TENNESSEE VALLEY AUTHORITY
BROWNS FERRY NUCLEAR PLANT (BFN)
UNITS 1, 2, AND 3

TECHNICAL SPECIFICATIONS (TS) CHANGES TS-431 AND TS-418 -
EXTENDED POWER UPRATE (EPU) - REPLACEMENT DOCUMENTATION
(TAC NOS. MC3812, MC3743, AND MC3744)

CALCULATION MDQ0999970046, REV. 10,
"NPSH EVALUATION OF BROWNS FERRY RHR AND CS PUMPS"

This enclosure provides TVA Calculation MDQ0999970046, Rev. 10,
"NPSH Evaluation of Browns Ferry RHR and CS Pumps."

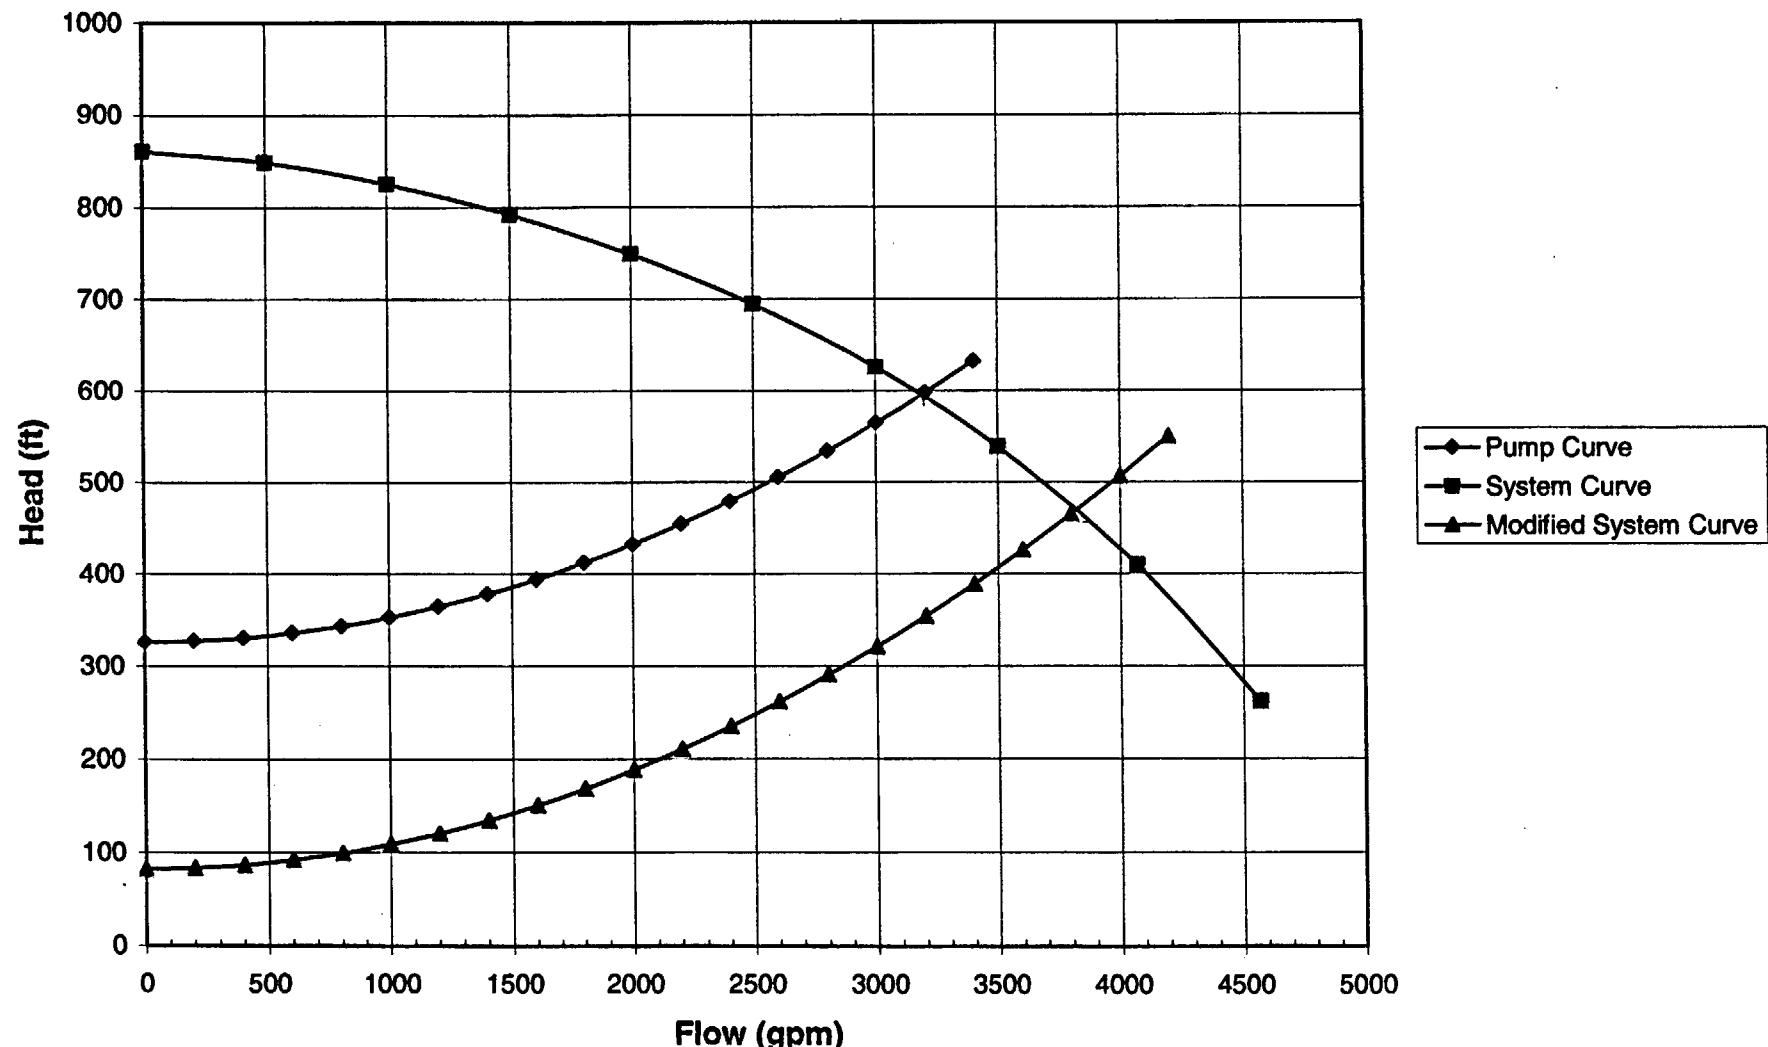
The revised calculation corrects the RHR pump flow rate for the evaluation of ECCS pump NPSH for the Appendix R transient. Figure 7.6, "RHR (Appendix R) pump curve and system curve," shows the corrected curves. This correction is reflected in the Appendix R results included in the calculation and used as input to TVA Calculation MDQ099920060011, Rev. 1 in Enclosure 2. Other refinements were made to the calculation which did not impact the results.

For the Appendix R condition a single pump curve is developed by utilizing points from the pump curve (Ref. 2.2). Table 6.4 shows points taken from Ref. 2.2 pump curve data. These points are used to develop the pump curve shown in Figure 7.6.

Based on Figure 7.6, the system operating point for the RHR pumps for the Appendix R cases is at 8,975 gpm with a corresponding head of 626 ft. This flow is less than the flow used in the model (9,100 gpm) and therefore the model provides conservative results.

From Figure 7.6 the operating point is found to be 7150 gpm at 183.3 psig reactor pressure. The Appendix R condition is based on a temperature of 223°F (Ref. 2.30). Utilizing the conversion factor at that temperature, 192 ft is converted to 83.3 psi.
